# **Authorized Field Change**

AFC G-06907R1

**Subject:** New Design Engine Block Heater to Eliminate Coolant Leakage in International® DT 570 Engines in certain 4000, 7000, 8000 HPV Models Built Between April 7, 2004 and July 19, 2006

Figure 1 Freeze Plug or Block Heater Removed Shown at Arrow

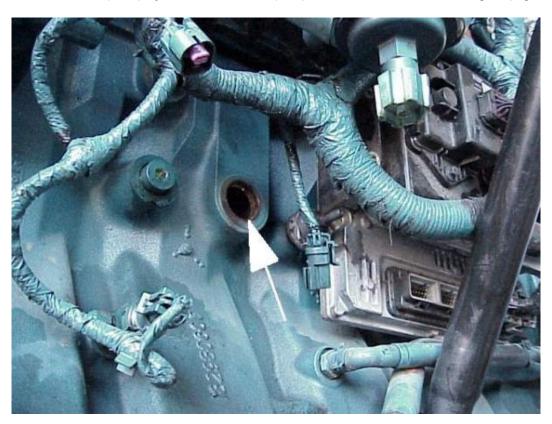
2. Remove the block heater or freeze plug and Loctite sealant, if so equipped, located forward of the engine control unit (ECU)/injector drive module (IDM) on the driver's side of the engine (Figure 1).

Figure 2 Install Block Heater

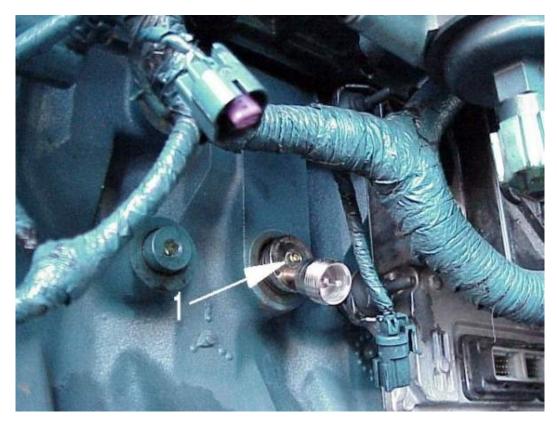
- 3. Clean the freeze plug bore and surrounding area with fine emery cloth moving in a circular motion around the opening. Do not move laterally across the bore. Ensure the bore is clean and smooth.
- 4. Lubricate the block heater seal ring with O-ring lubricant and install the block heater (Figure 2). Make sure the heating element is not in contact with any metal inside the engine block. When the block heater

is inserted properly into the bore, tighten the Allen head screw to 40 to 45 Lbf-in (4.5 to 5 Nm) to lock it in position.

Figure 3 Connect Power Lead

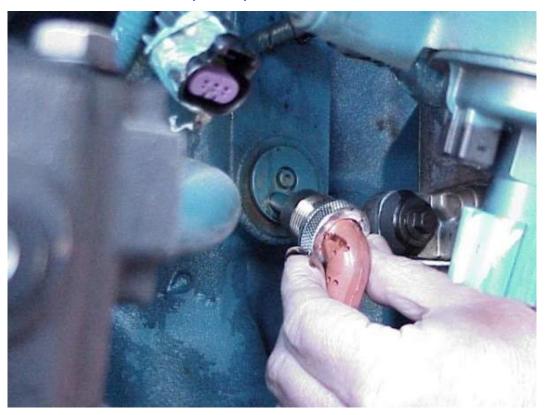
- 1. Allen Head Locking Screw
- 5. Connect the power lead to the block heater and secure it with the round nut (Figure 3).
